### **Application No.: PL9205**

Description :	
Address :	
Record Type :	PLAT

<b>Document Filename</b>
25081 Riverstone Ph1 Plat_2026_05_18.pdf

# FINAL PLAT OF RIVERSTONE TRAILS SUBDIVISION PHASE I

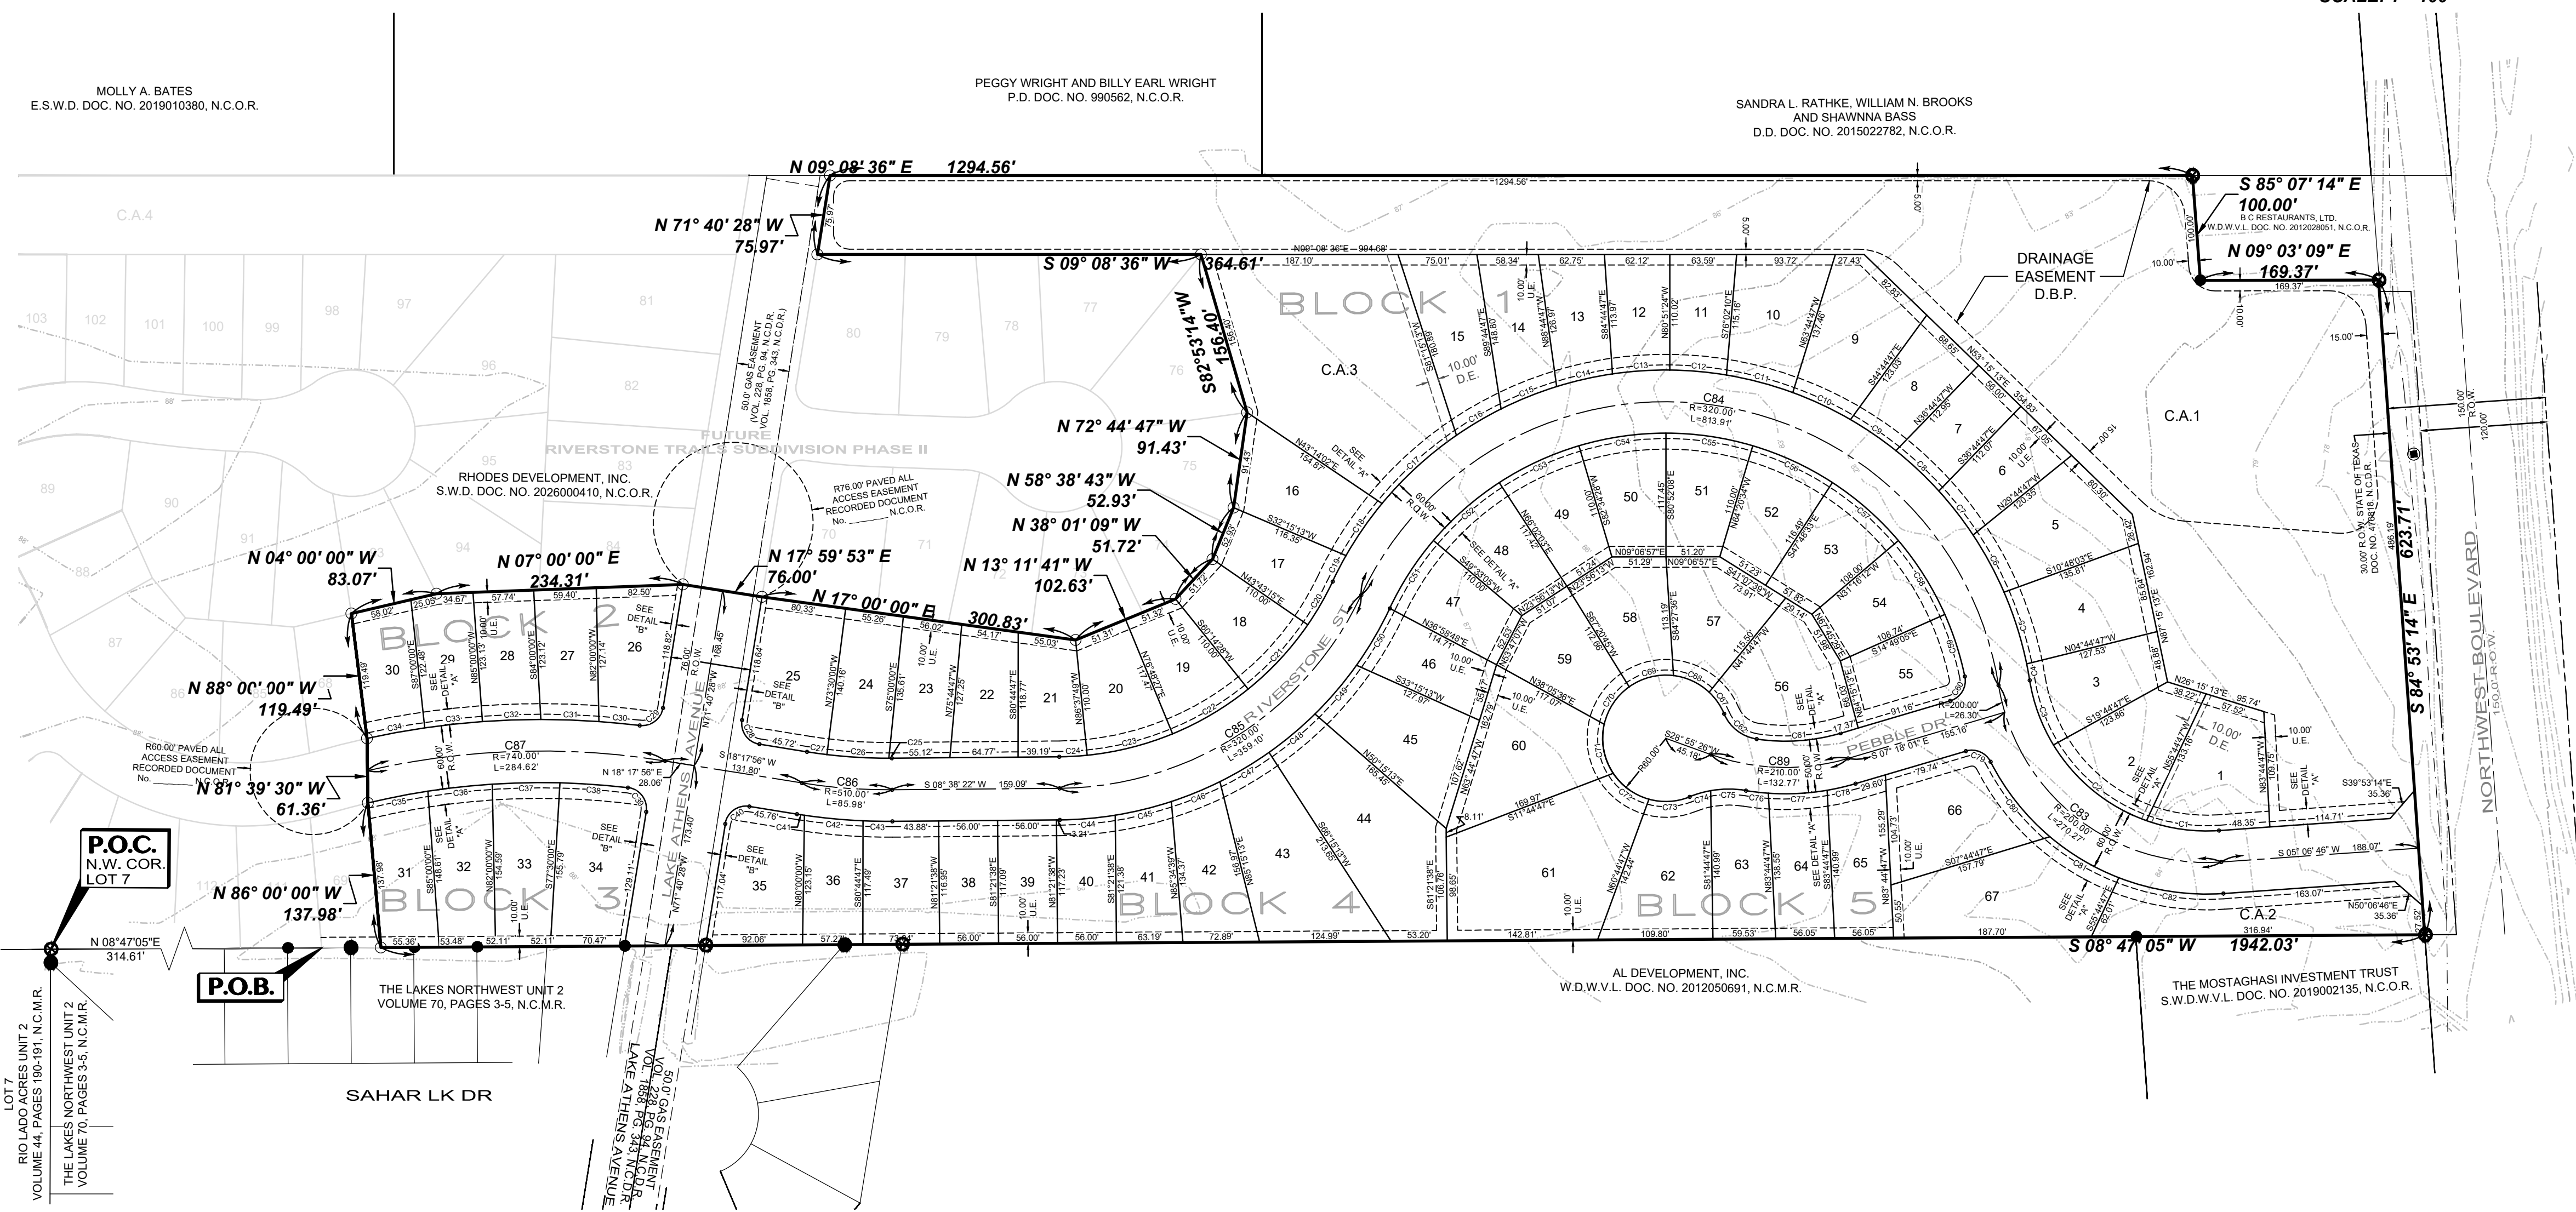
<b>Comment ID</b>	<b>Page Reference</b>	<b>Annotation Type</b>	<b>Author : Department</b>	<b>Status</b>	<b>Review Comments</b>	<b>Applicant Response Comments</b>
6	P001	Note	Mina Trinidad : DS	Closed	Remove preliminary plat and replace with "Final Plat"	
7	P001	Note	Mina Trinidad : DS	Closed	Metes and bounds not required to be on plat.	
8	P001	Note	Mina Trinidad : DS	Closed	Increase the street names on the location map for better visibility.	
9	P001	Note	Mina Trinidad : DS	Closed	Include owners name on signature block.	
10	P001	Note	Mina Trinidad : DS	Closed	Remove Michael Miller and replace with "Cynthia Salazar-Garza Chairperson"

26	P001	Note	Mina Trinidad : DS	Closed	NEC: (Carlos Guajardo) NEC will require a 5' exclusive easement in front of the lots, then the 10' utility easement. Please make the changes before final plat is approved.	
31	P001	Note	Mina Trinidad : DS	Closed	Traffic/ROW: (Moises T.) PLAT - ROADWAY MASTER PLAN The proposed plat does impact the existing Transportation Master Plan. The plat did provide adequate ROW dedication as required per the RMP.  PLAT - COMMENT: (CITY ACCESS MANAGEMENT / ROW) A ROW Construction Permit, issued by PW-Traffic Department (Right-of-Way Division), is required for any proposed driveway (construction entrance, temporary or permanent), work obstructing, closing, or occupying public right-of-way (Reference Chapter 49-2). The ROW Construction permit must be submitted and approved prior to any form of construction within City ROW. The developer / applicant can reach out to rowmanagement@corpuschristitx.gov for further assistance regarding the ROW Construction Permit they will be required to submit prior to any temporary and / or permanent driveway off the immediate roadways.

35	P001	Note	Mina Trinidad : DS	Closed	Incorporate the street cross sections as part of the final plat as it will be recorded as well.	
35	P001	Note	Mina Trinidad : DS	Closed	Update 05/18/2026: Asked applicant to remove street cross sections and pavement details due to being approved on Preliminary Plat. Will also resolve Streets Dept comments.  Incorporate the street cross sections as part of the final plat as it will be recorded as well.	
35	P001	Note	Mina Trinidad : DS	Closed	Update 05/18/26: Asked applicant to remove street cross sections and pavement details due to being approved on Preliminary Plat. Removing will resolve open Streets Dept comments as well.  Incorporate the street cross sections as part of the final plat as it will be recorded as well.	
36	P001	Note	Mina Trinidad : DS	Closed	04/01/2026: Pending comments from Parks and Recreation Department and Engineering	
37	P001	Note	Mina Trinidad : DS	Closed	Remove the county clerk signature block on sheet 2 of 2.

38	P001	Note	Mina Trinidad : DS	Closed	Label C36 on the plat.	
38	P001	Note	Mina Trinidad : DS	Closed	Label C36 on the plat.	
38	P001	Note	Mina Trinidad : DS	Closed	Label C36 on the plat.
